UNITED STATES PATENT AND TRADEMARK OFFICE

APPLICATION NO.	FILING DATE	FIRST NAMED INVENTOR	ATTORNEY DOCKET NO.	CONFIRMATION NO.
10/699,833	11/04/2003	Noriyuki Horiuchi	SN-US035134	5570
22919 7	7590 12/17/2004		EXAM	INER
	LOBAL IP COUNSELO	ROYAL, PAUL		
	REET, NW, SUITE 700 N, DC 20036-2680		ART UNIT	PAPER NUMBER
	, = = = = = = = = = = = = = = = = = = =		3611	
			DATE MAILED: 12/17/200	4

Application No.	Applicant(s)	il /ò-			
		10/699,833	HORIUCHI, NORIYU	JKI 1°			
Office Action Summary		Examiner	Art Unit				
		Paul Royal	3611				
Period f	The MAILING DATE of this communication app or Reply	pears on the cover sheet w	vith the correspondence addre	ess			
A SH THE - Extrafte - If th - If N - Fail	HORTENED STATUTORY PERIOD FOR REPLY MAILING DATE OF THIS COMMUNICATION. ensions of time may be available under the provisions of 37 CFR 1.1 or SIX (6) MONTHS from the mailing date of this communication. He period for reply specified above is less than thirty (30) days, a reply openiod for reply is specified above, the maximum statutory period or the toreply within the set or extended period for reply will, by statute or reply received by the Office later than three months after the mailing

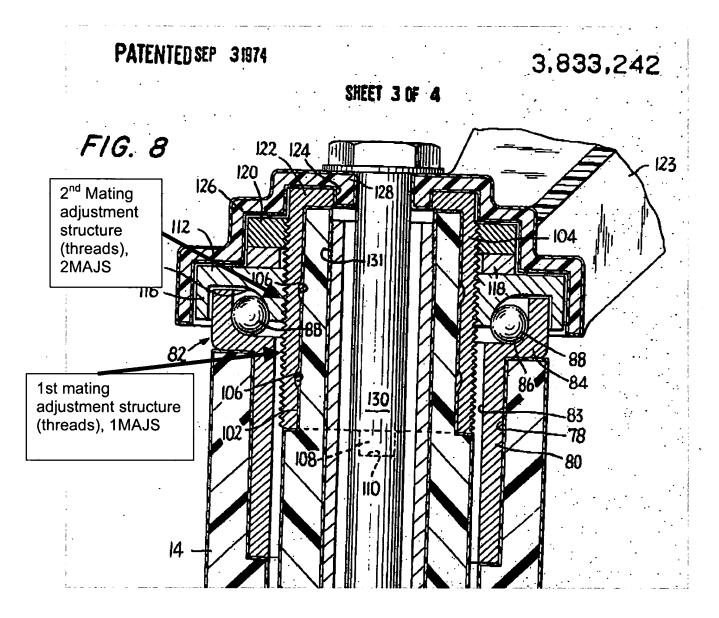
Thompson, Jr. teaches an expandable bicycle headset structure comprising: a first tubular member (104) having a first free end, a first coupling end with a first

mating adjustment structure (1MAJS, see Examiner's annotated Figure 8), and a first bore extending axially between the first free end and the first coupling end, the first bore having an innermost diameter that is sized to receive a steerer tube (92) therethrough; and

a second tubular member (112) having a second free end, a second coupling end with a second mating adjustment structure (2MAJS, see Examiner's annotated Figure 8), and a second bore extending axially between the second free end and the second coupling end, the second bore having an innermost diameter that is sized to receive the steerer tube (92) therethrough, the first and second mating adjustment structures being adjustably coupled together to change an effective overall axial length of the expandable bicycle headset structure; and

a locking member (120) configured and arranged to be selectively set to prevent relative adjustment between the first and second mating adjustment structures,

wherein the first mating adjustment structure (1MAJS) includes a set of first threads, and the second mating adjustment structure (2MAJS) includes a set of second threads that are threadedly engaged with the first threads, and

the locking member (120) includes a locking nut that is threadedly coupled to one of the first and second threads, and

the first threads are external threads formed on an outer surface of the first tubular member (104), and the second threads are internal threads formed on an inner surface of the second bore of the second tubular member (112), and

Note, Thompson, Jr. teaches maintaining spacing between the bearing races 86 and 114 which is understood to teach the first (1MAJS) and second (2MAJS) mating adjustment structures being adjustably coupled together to change an effective overall axial length of the expandable bicycle headset structure, see column 6, lines 31-45, specifically, lines 42-45.
